Item ID: D2580-1 Accept ***N900040100*** Setup Start ***NS1***
Revision ID: Stop ***NS2***
Item Name: 205 Skidtube bent detail
Start Date: 11/01/2012 Start Qty: 2.00 ***2*** Cust Item ID:
Required Date: 13/01/2012 Req'd Qty: 2.00 ***2*** Customer:
Reference:

DRAWING NO. REV. E
D2580 SHEET 1 OF 8

DRAWING NO. D2580	TITLE 205 SKIDTUBE ASSEMBLY	REV. E	DART AEROSPACE LTD ENGINEERING ORDER	D.E.O. NO. D2580-E-1	SHEET NO. SHEET 1 OF 1	SCALE NTS
DRAWN <i>up</i>	CHECKED <i>ASS</i>	MFG. APPR. <i>ER</i>	APPROVED <i>#</i>	DE APPR. <i>#</i>		
DATE 11.12.13	DATE 11.12.13	DATE 11.12.13	DATE 11.12.13	DATE 11.12.13

CHANGE ALL C'BORED WELDED CROSSBOLT SPACERS TO SWAGED SPACERS

D5-2
SECTION B-B
SCALE 5X

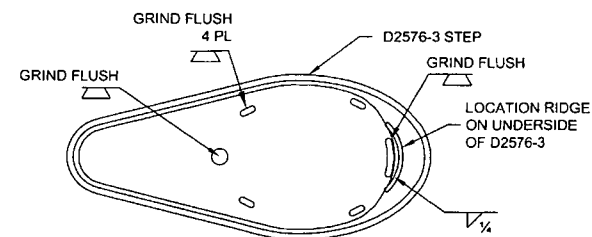
SECTION B-B, SECTION F-F, & SECTION I-I ARE AMENDED AS FOLLOWS
FOR ALL HOLES THAT WERE ORIGINALLY C'BORED:

1. INSERT D4202-1 SPACER, 20 PL (-041) OR 20 PL (-045) OR 25 PL (-047)
2. SWAGE TO Ø0.437 X 1.00 DEEP PER QSI 002
3. TRIM / GRIND FLUSH PER QSI 002

SECTION B-B, F-F, I-I
NOT TO SCALE

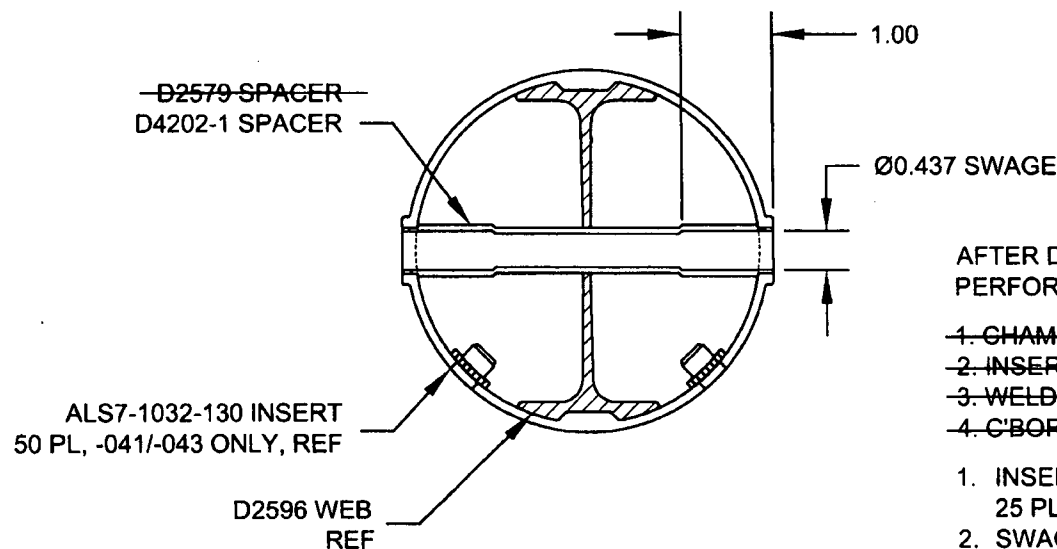
*** FOR -045 SKIDTUBE ONLY:**
WELD 4X D2579 SPACERS PER DWG
IN LOCATIONS MARKED "NO C'BORE".
REF SHEET 4 OF DWG.

- ~~1. CHAMFER HOLE 0.060 X 45°~~
- ~~2. INSERT D2579 SPACER (20 PLACES)~~
- ~~3. WELD INTO PLACE AND GRIND FLUSH~~
- ~~4. C'BORE D2579 SPACER TO Ø0.437 X 1.00 DEEP~~
